**Proposed Rezoning from “Residential (Group B)1” Zone to “Residential (Group B)4” Zone  
for Medium-Density Housing Development to Include a Footpath for Public Use at Various  
Lots and Adjacent Government Land in DD130, Lam Tei, Tuen Mun  
– S12A Amendment of Plan Application –  
TPB Ref.: Y/TM-LTTY/11  
Further Information No. 4**

## **Response-to-Comment Table**

**Further Information No. 4**

Sightline for T1\_RN02\_21-25/F

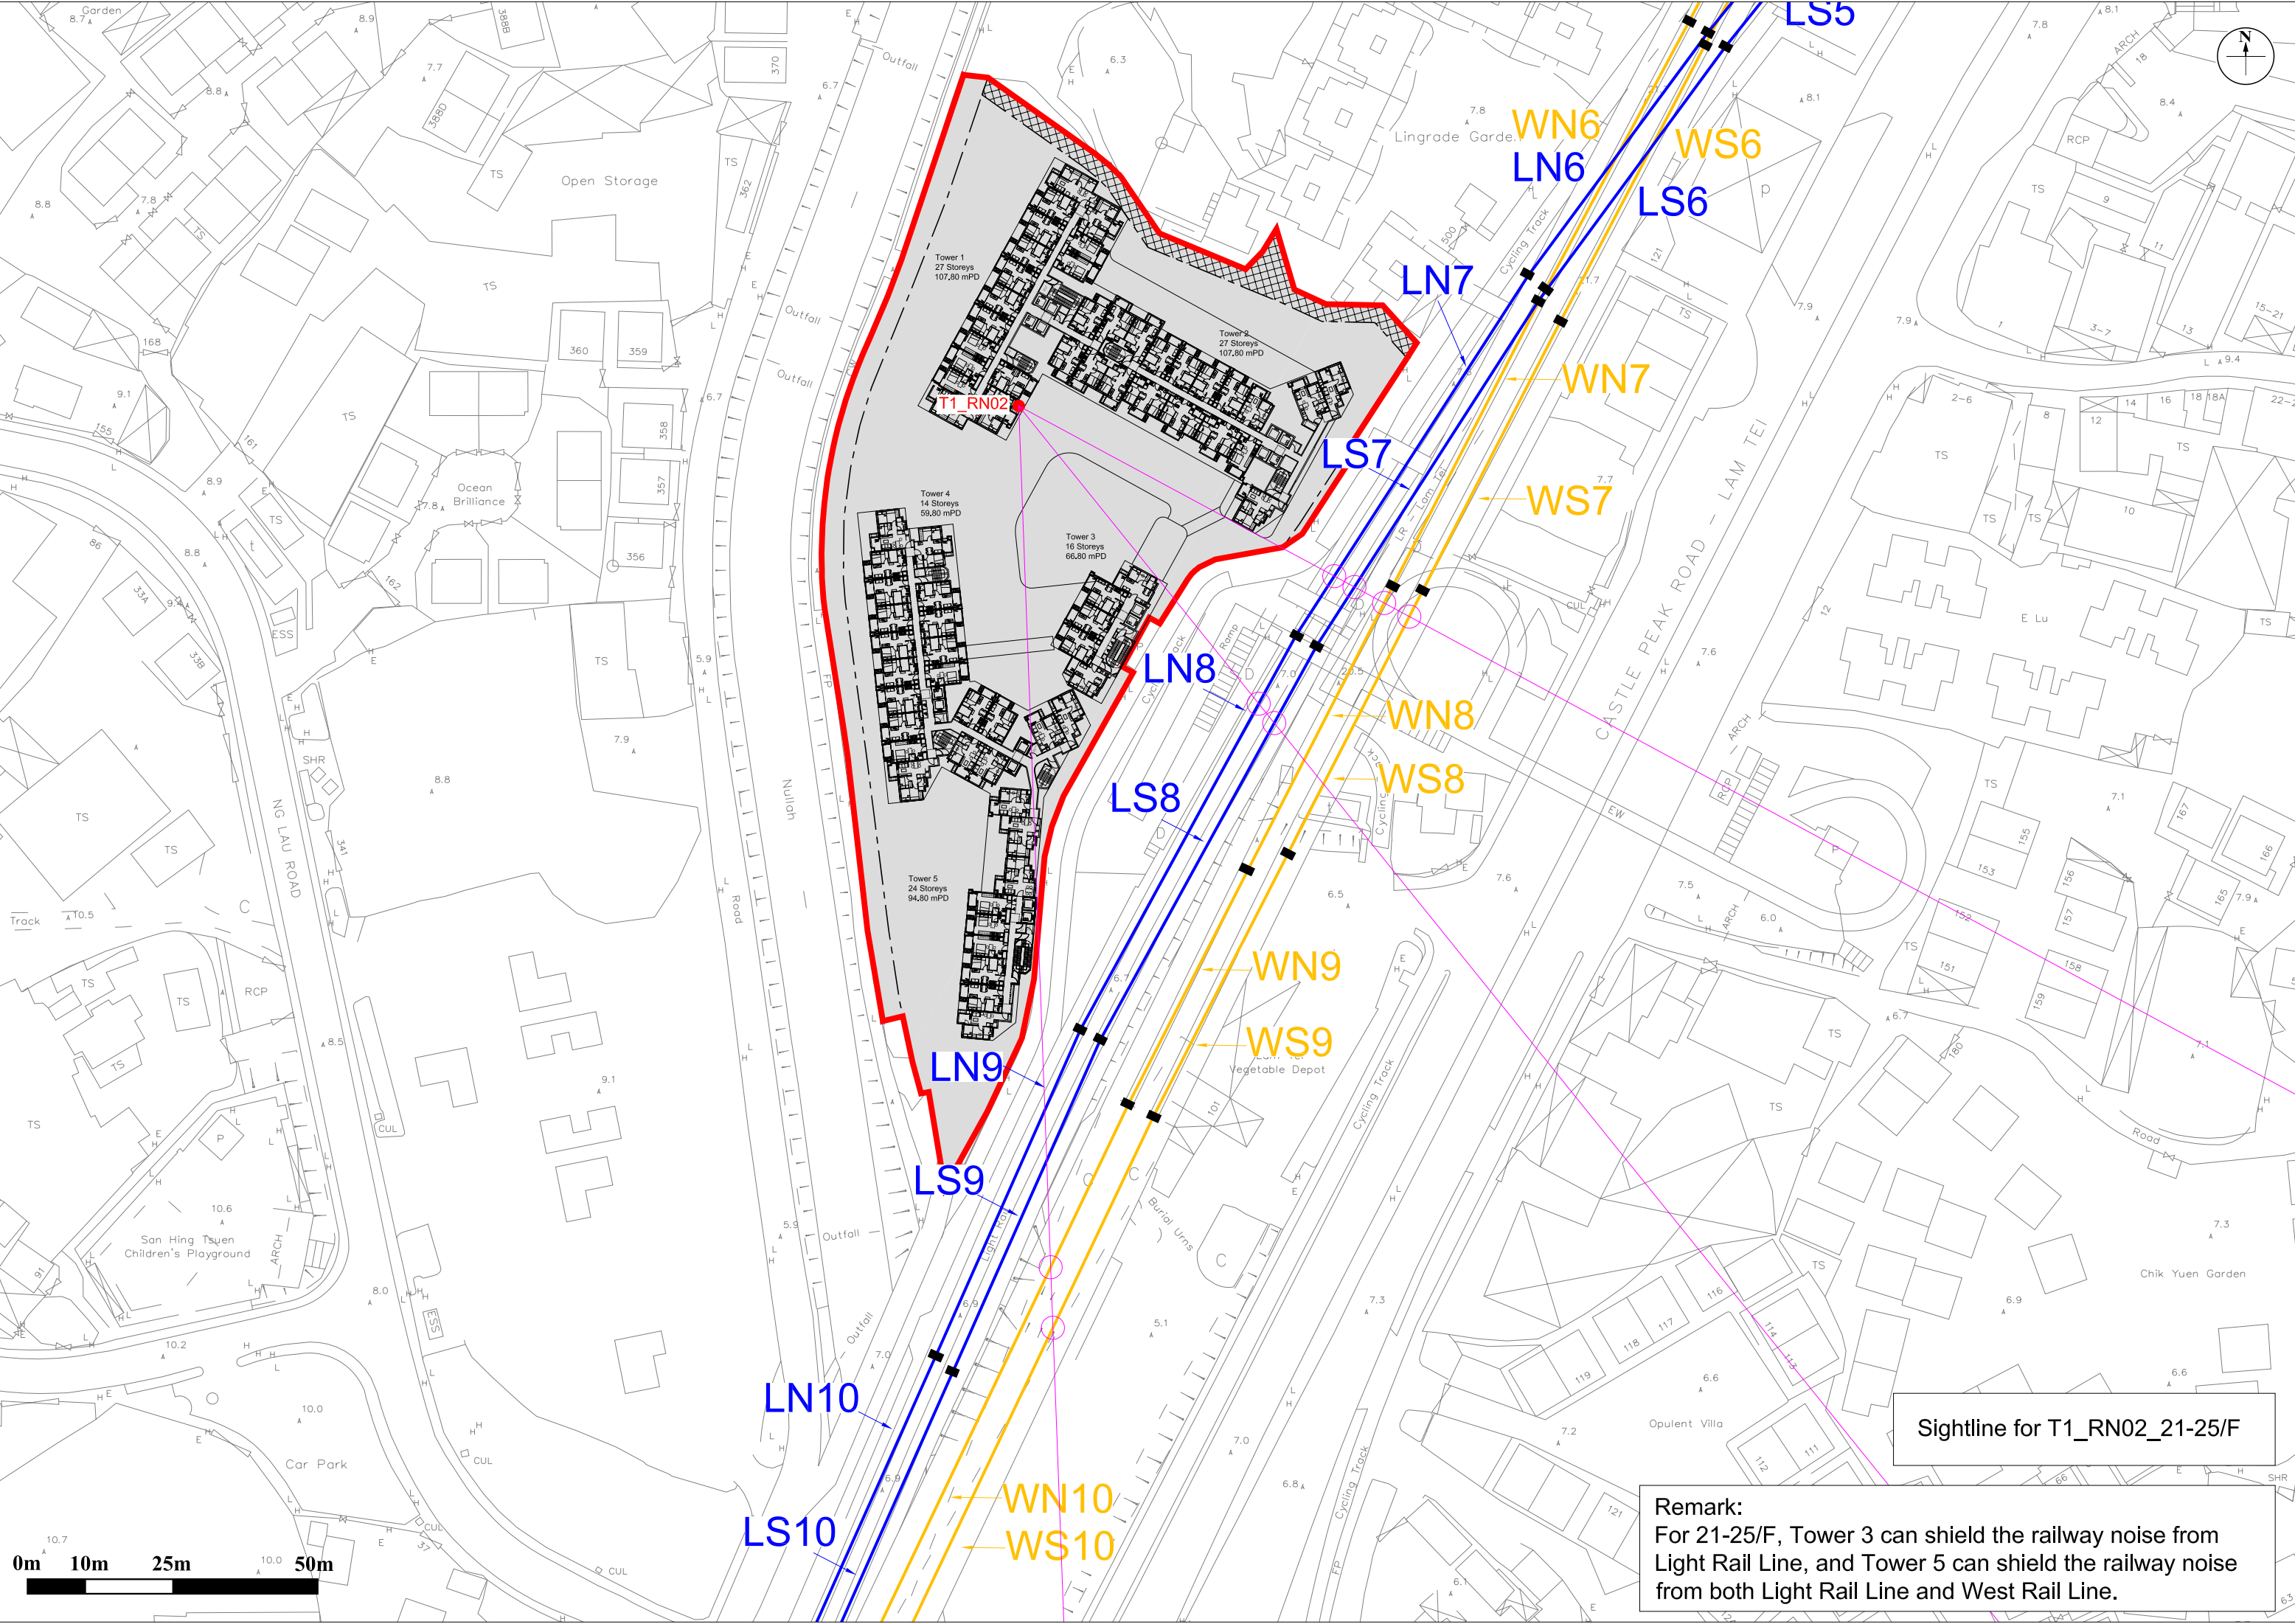
Item	Comments	Our Responses
37.	<p>The circled figure showed that solid parapet correction was applied between some NSRs and the West Rail Line Track/ Light Rail Track. Please provide more information, if there is any solid structures between the track and NSR, and it should be showed clearly in all figures (pointing out with suitable legend).</p> 	<p>The location of solid parapet and full enclosure for TML and LRT have been added to Figures 2.1 and 2.2. With reference to the information in the West Rail Operational Train Noise Assessment Report and EIA Report for Development of San Hing Road and Hong Po Road, Tuen Mun (AEIAR-227/2020), solid parapet with a height of 1.2m has been assumed for all TML segments and some LRT segments within the assessment area.</p>

Remark:  
For 21-25/F, Tower 3 can shield the railway noise from Light Rail Line, and Tower 5 can shield the railway noise from both Light Rail Line and West Rail Line.

Sample Calculation for T5\_RN01 at 1/F (15.5 mPD)  
(Daytime Scenario)

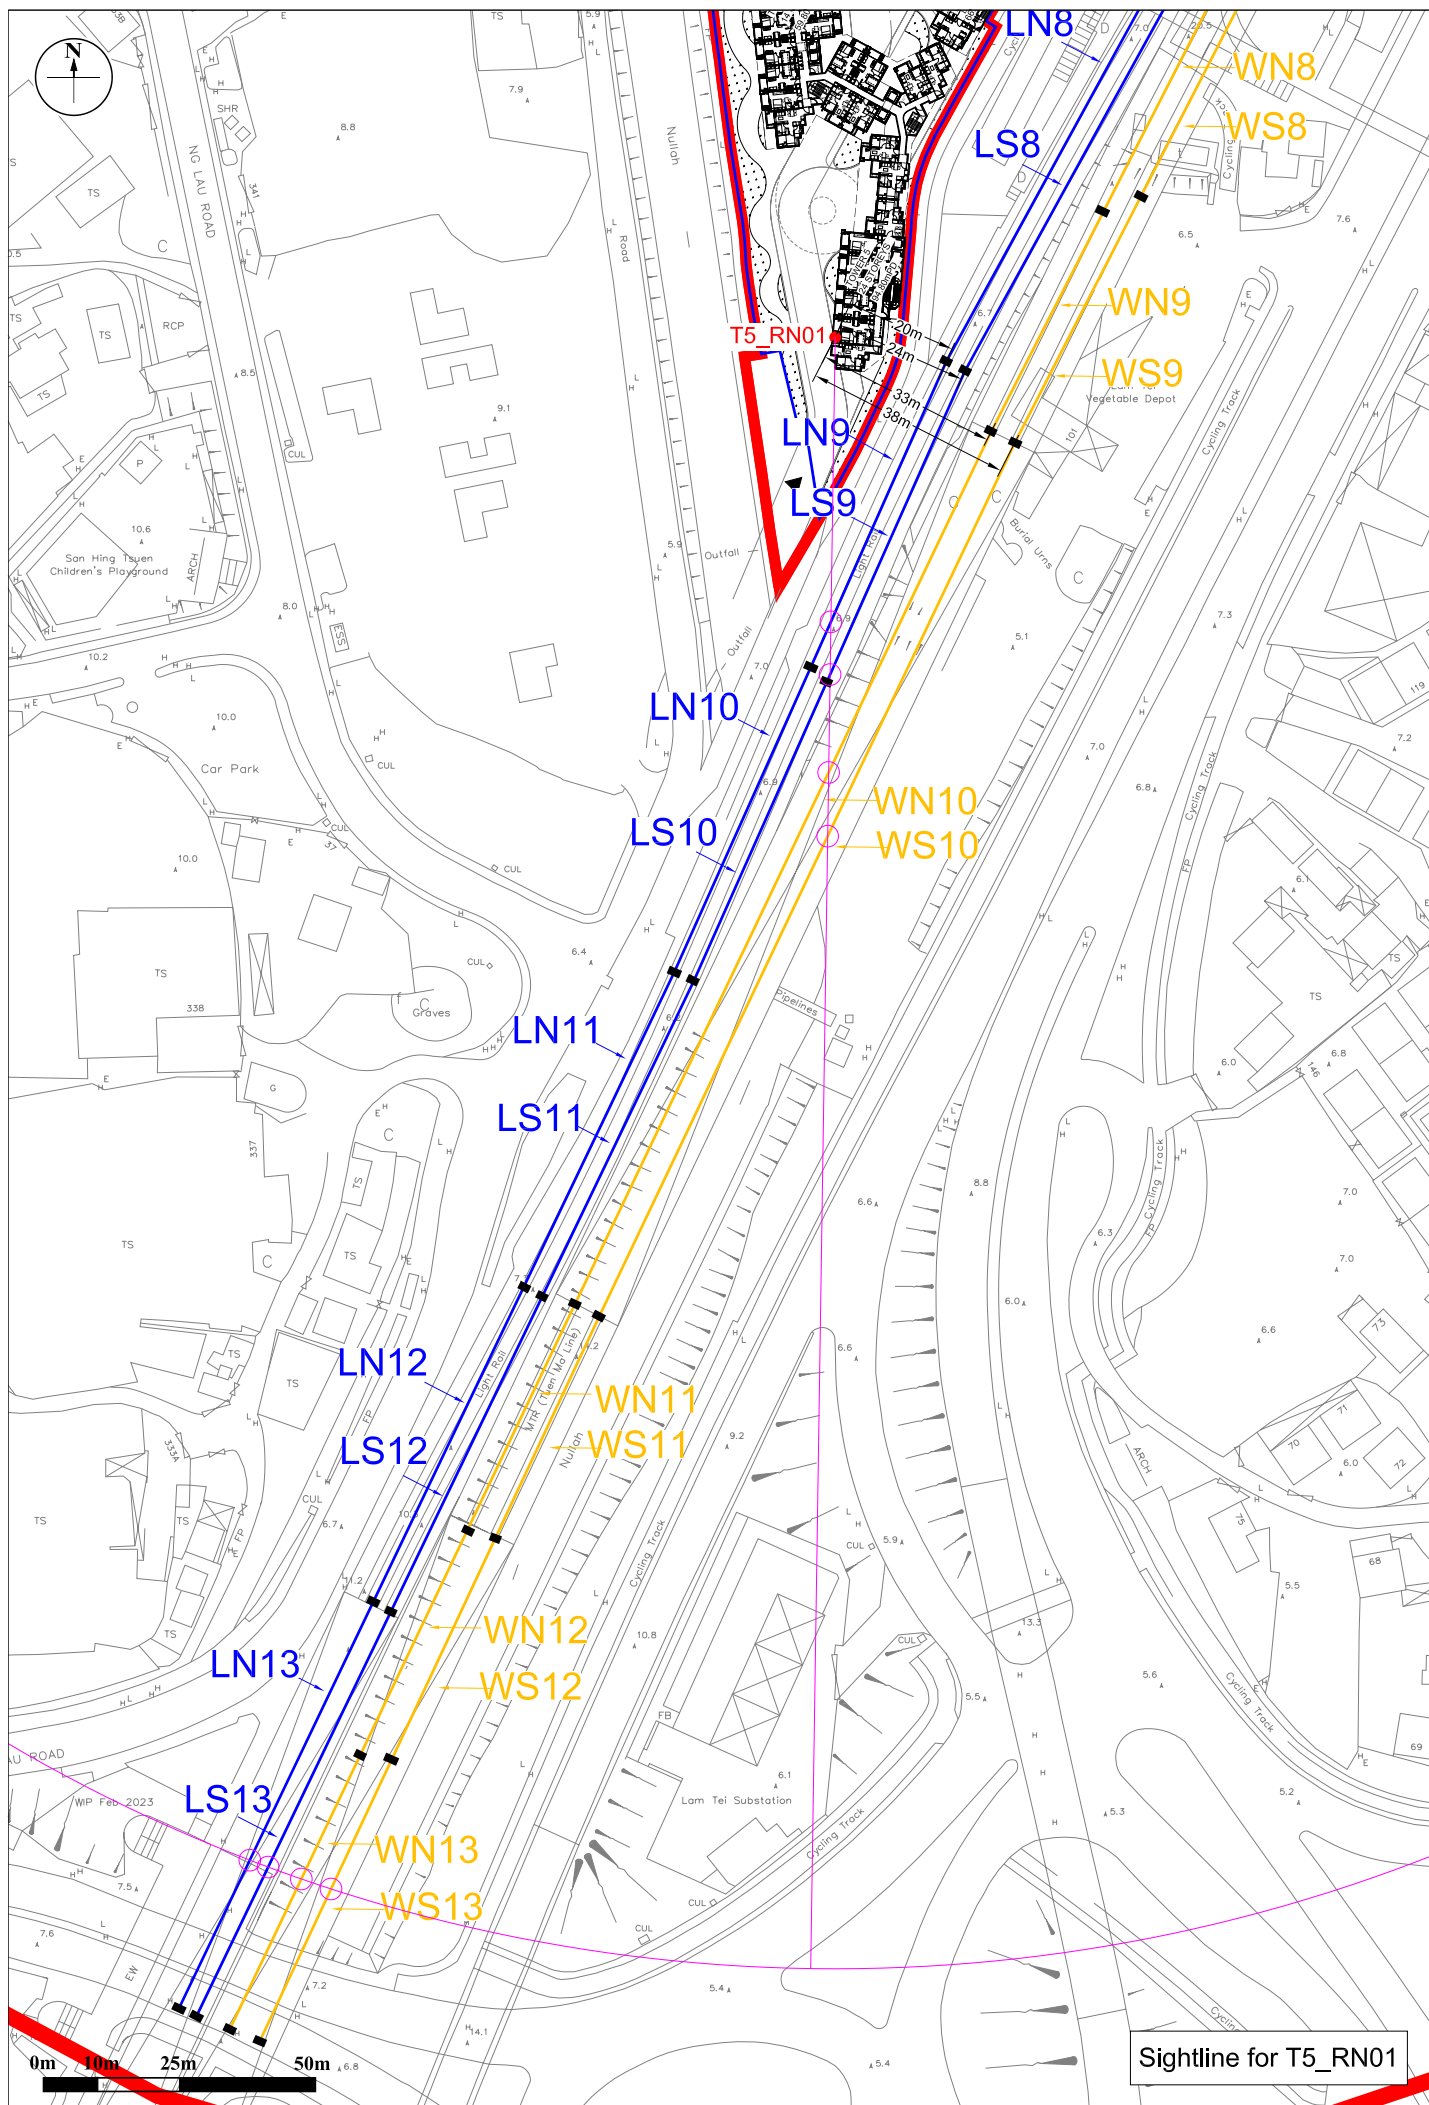
38.	<p>For T5_RN01, only track segment LN9, LS9, partial WN10, WS10 was shown in Fig 2.2. Please provide a clear figure to show the relationship between T5_RN01 and all mentioned track segments in the sample calculation worksheet.</p>	<p>Please find the sample calculation worksheet of T5_RN01 in Attachment A.</p>
